COA # 2010-COA-401(SJ) 2010-ZON-058	INDIANAPOLIS HISTORIC PRESERVATION COMMISSION STAFF REPORT	Hearing Date OCT 6, 2010
1030 N CENTRAL AVE SAINT JOSEPH		NEW CASE
Applicant JASON COMER AND KARA HIESER mailing address: 2463 N Park Ave. Indianapolis, IN 46205		Center Township Council District: 9 Jackie Nytes
Owner: Same as above		
COMBINED CASES		
IHPC COA: 2010-COA-401 (SJ): <ul style="list-style-type: none"> • Replace all windows in 2-story addition • Remove one-story rear addition • Paint • Repair and infill stucco • Install new window at front elevation (gable area) • Replace entry doors with new doors • Repair glass block windows • Remove stucco from chimney and tuckpoint • Reconstruct gabled roof and alter pitch to line up with height of two-story rear portion of building • Install new trim where necessary • Install wood privacy fence around rear yard • Modify parking area at rear of site and resurface parking area • Rezone

Rezone: 2010-ZON-058	<ul style="list-style-type: none"> • Rezone property from C-4 to CBD-2 (Recommended) 	
STAFF RECOMMENDATION: Approval with stipulations

SCALE: 1" = 20'

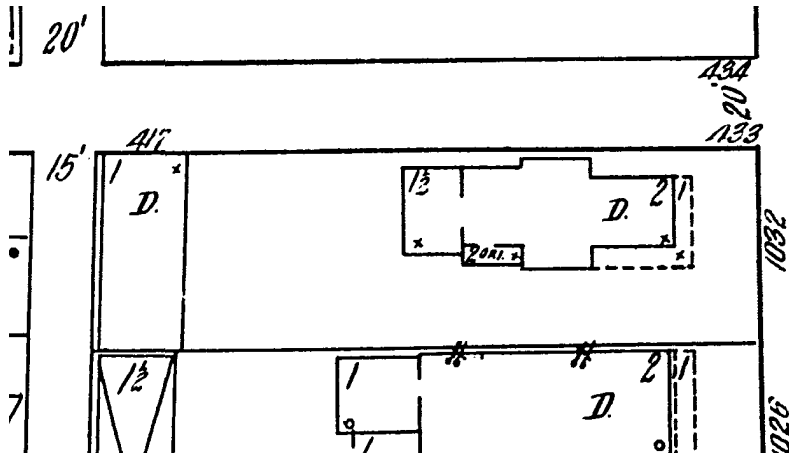
This area is currently gravel parking.
We propose to change to blacktop parking.

Proposed 6' Flat top privacy fence.

Concrete slab for parking. (Existing)

Proposed demolition of 18x20 addition.

Above: IHPC Staff drawing of proposed roof pitch alteration in perspective
Below: Applicant drawing of proposed roof change

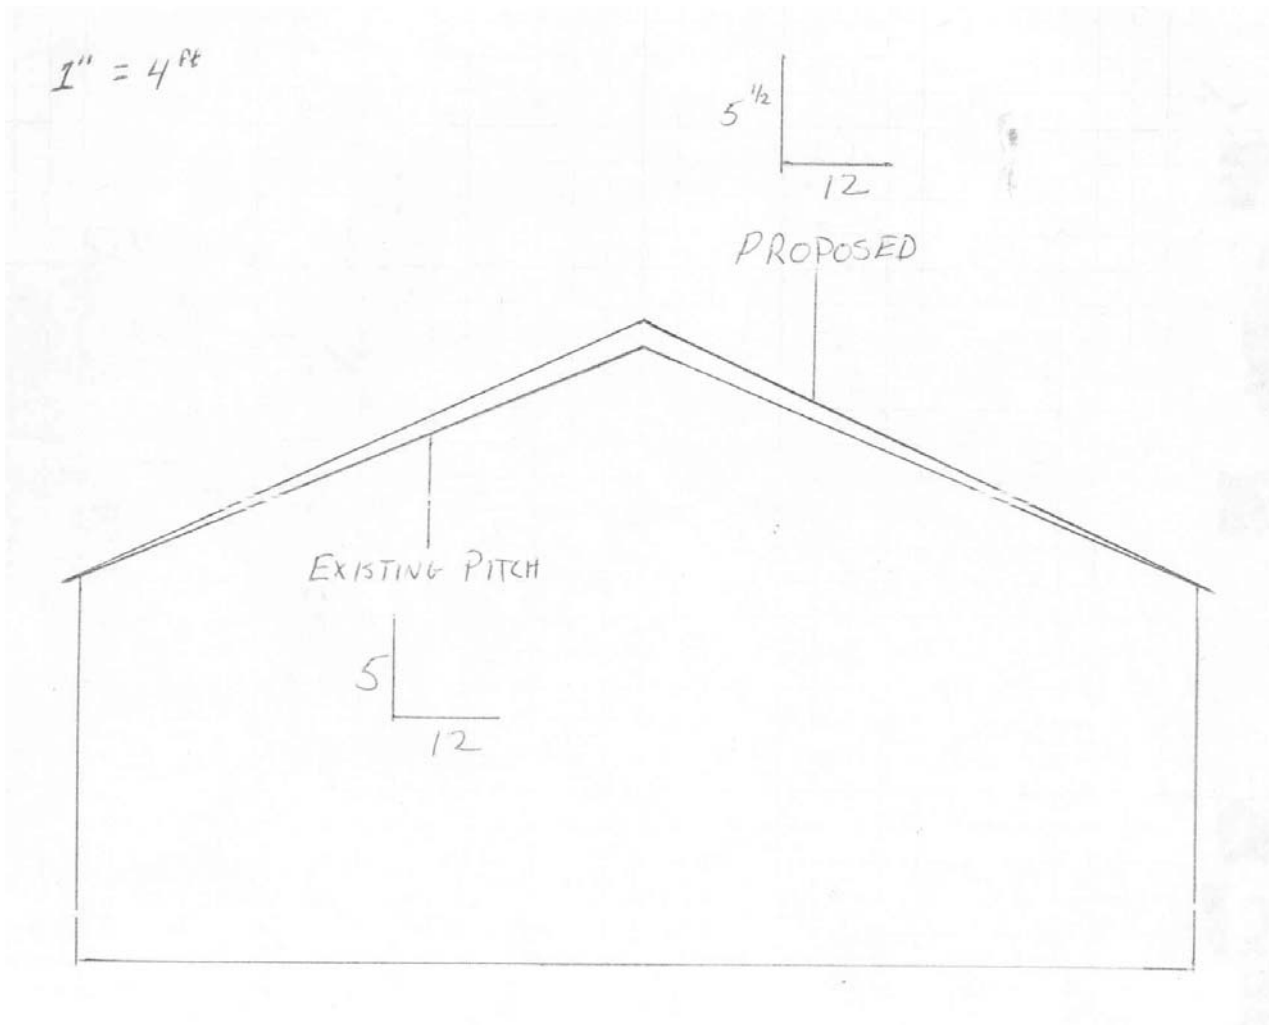
The proposed roofline change seems reasonable to staff. The fire that occurred in 2009 damaged the roof structure, and while fixing it, the applicant would like to line the pitch up with the two-story rear addition. This will create enough head height for the applicant to have attic storage space while making only a minor visual change to the roof shape. The alteration will add approximately one foot to the overall height, and will change from a 5/12 to a 5 1/2 /12 pitch. The new front-facing gable window is to be inserted into the existing opening where a fan currently exists. A window or vent may have been in this opening, but staff is not aware of any historic photos of the building to prove this theory. However, a window seems perfectly appropriate at this location.
